Subject: Oconee Nuclear Station
Docket Nos. 50-269, -270, -287
Second Ten Year Interval
Request for Relief No. 89-04

DUKE POWER COMPANY
OCONEE NUCLEAR STATION

Second Ten Year Interval
Request for Relief No. 89-04

Main Steam Turbine Stop Valve Upper Head to Valve Body Studs.
Valve Manual OM-200-195 (See Attached Figures).

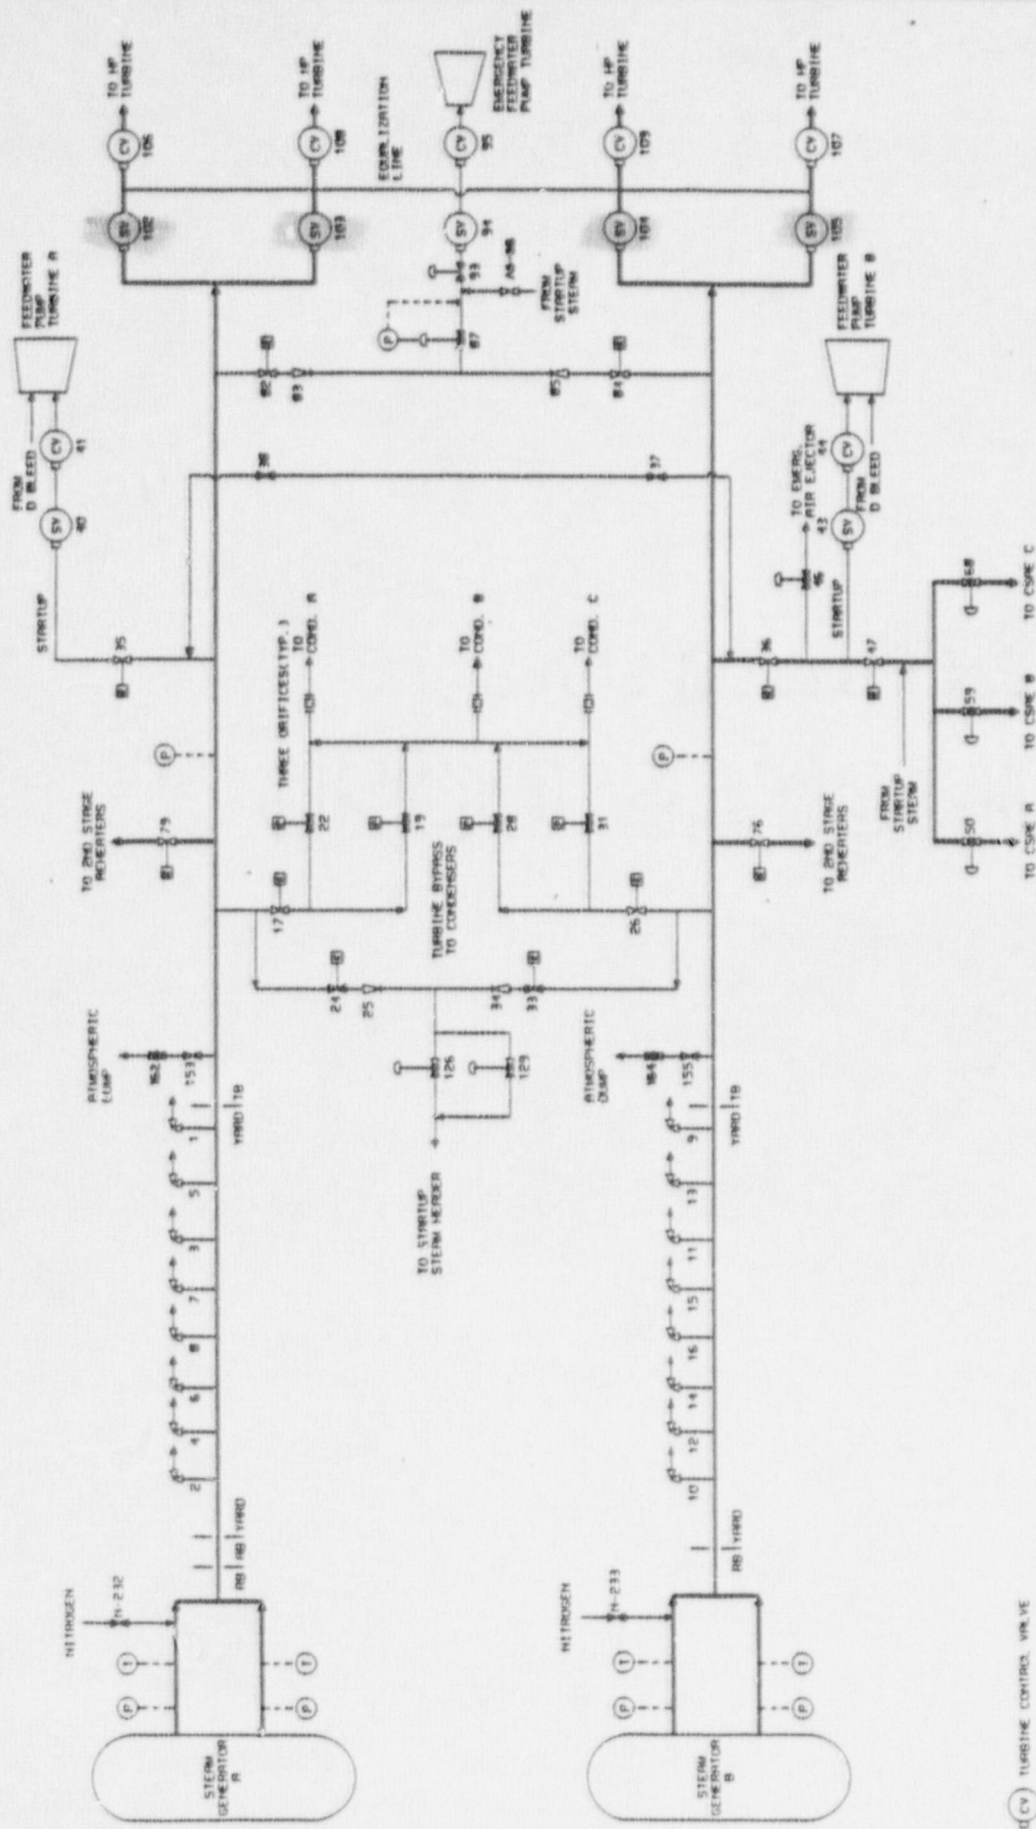
ASME Section XI, IWC2500-6 requires that the full volume of the thread portion of the stud be examined. This request for relief is on the premise that even though the code requires a volumetric examination of the entire length of the stud, the actual areas of concern would be the thread run-out points, where the threads meet the body of the stud; the first three to four threads that engage the nut.

The Design Engineering Department of Duke Power Company performed an evaluation to support this request. It was concluded that the last 2.9" of the stud that is engaged in the valve body would not have any significant load that would lead to the stud's failure. Further, the stud manufacturer, General Electric (GE), in their document "Valve Studs-Tightening, Inspection & Replacement Recommendations (TIL-891)", states; "The results obtained to date indicate that crack indications will appear at the first or second thread, 0-1/4 inch below the valve joint surface..."

Article 5 of ASME Section V, Paragraph T-541.5 specifies the ultrasonic examination be performed from the end of the bolt. Calibration shall be established from a 3/8" diameter, 3" long, flat bottom hole drilled in the end of the calibration standard(s) with dimensions as identified in Table 541.5.2. Configuration of the Main Steam Upper Head Studs on the Turbine Stop Valve prevents this technique from being properly utilized.

The Main Steam Turbine Stop Valve Upper Head Stud is configured with a .620" diameter heater hole that runs 11.13" of the length of the stud. An in-place examination using an ultrasonic angle beam transducer can be performed from the heater hole.

ASME Section XI 1983 winter addenda specifies that a procedure qualification be performed in accordance with Paragraph VI-2430. The sensitivity of the examination shall be established using a qualification specimen with notches of dimensions that are specified in Table VI-2430-1. The ultrasonic examination specified in Article 5 of ASME Section V, Paragraph T-541.5 can not be performed using that calibration block design. However, an angle beam examination has been established using the qualification specimen design identified in the ASME Section XI 1983 winter addenda, Paragraph VI-2430. This technique is an in-place examination that employs a 45 degree angle beam transducer through the heater hole. It is capable of detecting cracks from the top of the stud to the last two threads engaged in the valve body. This is approximately 1.5" beyond the critical area identified in the Design Engineering evaluation.
